Subject: EPA Comments on Final Environmental Impact Statement (FEIS) for the Ocean Isle Beach Shoreline Protection Project, N.C.; CEQ Number: 20160084

# Enclosure: EPA Detailed Technical Comments Town of Ocean Isle Beach Shoreline Protection Project Brunswick County, North Carolina Final Environmental Impact Statement CEO No.: 20160084

Brunswick County GIS Map

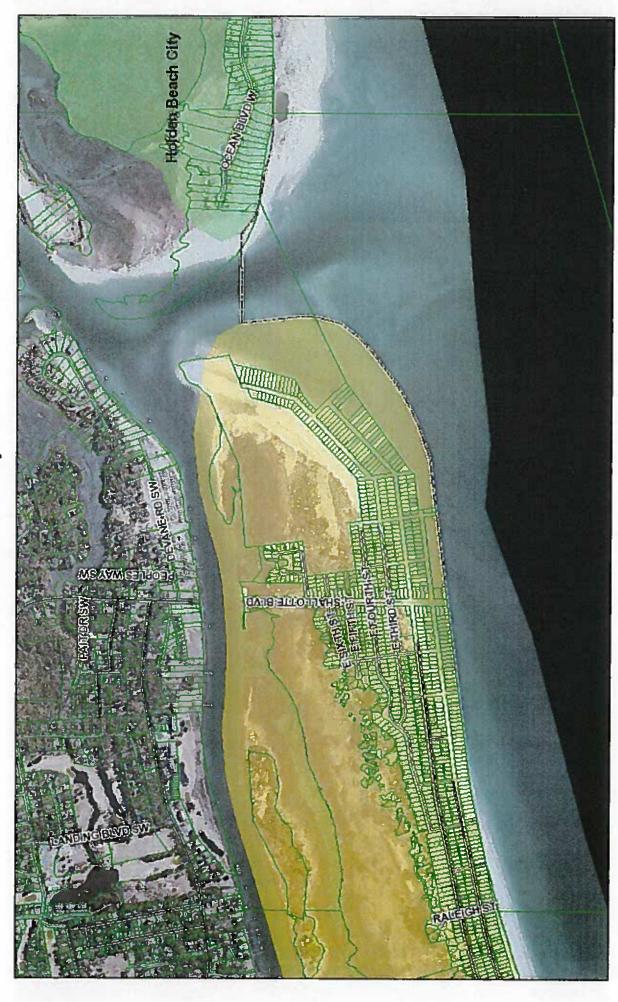
A further review of Brunswick County GIS data show more than 80 parcels located off the eastern end of OIB that are already submerged (Please see the attached map). If any of these parcels are actually being counted as 'protected parcels' by the proposed project, this should have been fully disclosed during the NEPA process. In addition, if new development is being proposed on the eastern end of OIB, the cumulative impact of this additional development should also have been disclosed during the NEPA process. The EPA considers these issues vital to an objective decision-making process. Therefore, the EPA believes that these issues need to be fully
